SAFETY NOTICE AND REPLACEMENT PROGRAM

BLACKHAWK! SERPA Level 3 Light Bearing Duty Holsters (Manufactured Before October 2011)

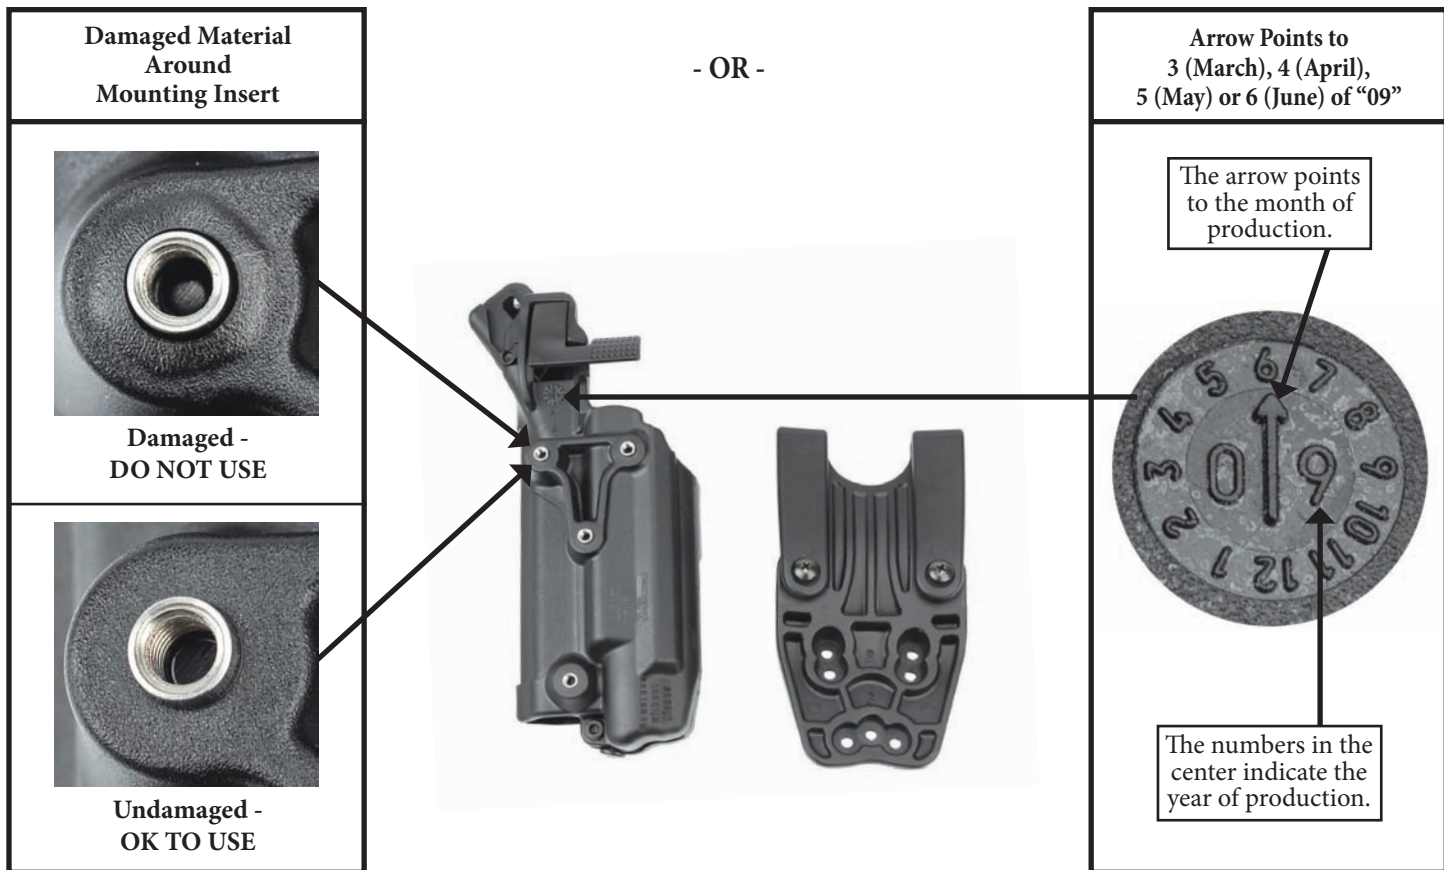
BLACKHAWK! has received reports of SERPA **LIGHT BEARING** duty holsters detaching from their mounting platform under certain conditions. This generally occurs if the user damages the material surrounding the screw insert (see picture below) by using extreme force when tightening the mounting screws or by mounting the holster using incorrect or missing screws. In addition, a small number of **LIGHT BEARING** holsters manufactured in March-June of 2009 may contain parts that can contribute to this condition.

To see if your holster is affected, remove the mounting platform and inspect the back. **DO NOT USE** your Light Bearing holster if either of the following apply:

Although this condition only affects a limited number of holsters, to prevent future damage from occurring BLACKHAWK! recommends you replace your holster, and is offering a free upgrade for all owners of SERPA **LIGHT BEARING** holsters manufactured before October 2011. If your **LIGHT BEARING** holster qualifies under this program, visit www.blackhawk.com and follow the instructions, e-mail BLACKHAWK! at lbholsterreplacement@blackhawk.com or call customer service at 800-694-5263. We will pay for all shipping costs.
